# 2014 - 2015 Corvette: Service Bulletin: Creak or Snap Noise Above Windshield from Removable Roof Lift Off Panel While Driving

**GM Bulletin No.:** #15-NA-016

**Date:** September 30, 2015

**MODELS:** 2014 - 2015 Chevrolet Corvette

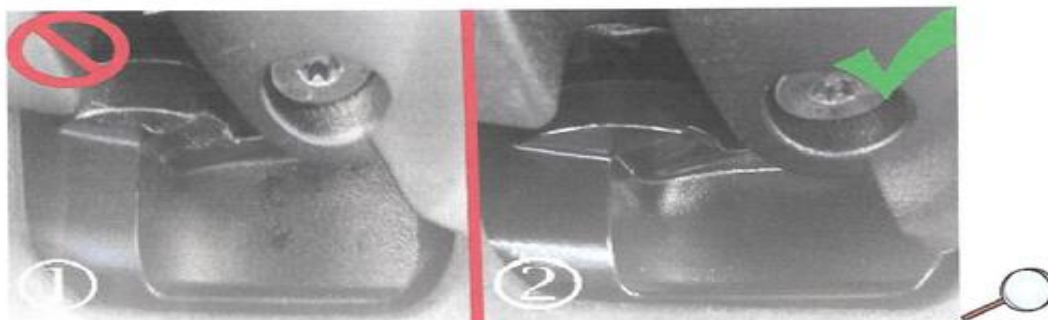
**CAUSE:** This may be caused by a stick-slip condition between the front latches against the strikers and the front locating pins to the locating cup in the strikers.

- (1) Example of a bad front locating pin.
- (2) Example of a good front locating pin.

- (1) Example of a bad striker.
- (2) Example of a good striker.

If you encounter a vehicle with the above concern, replace both the front roof lift off panel strikers and both front locating pins. Refer to Roof Lift Off Panel/Window Front Striker Replacement and Removable Top Locating Pin Replacement in SI.
